Notes:

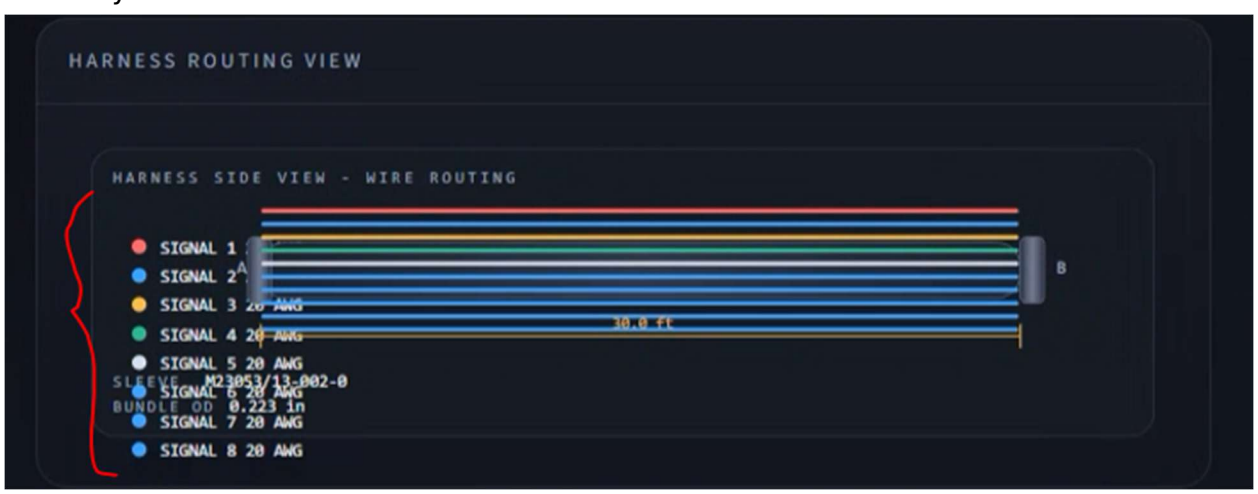
1. [CRITICAL PRIORITY] Add black as a color option in input section
2. [CRITICAL PRIORITY] AWG needs to be visible for all conductors. For simplicity, remove A/B designators; only signal names should be shown on the harness left, and corresponding AWG values shown on the right.

3. [CRITICAL UPDATE] As conductor count grows, the harness routing view table also needs to expand, and it needs to format
correctly.
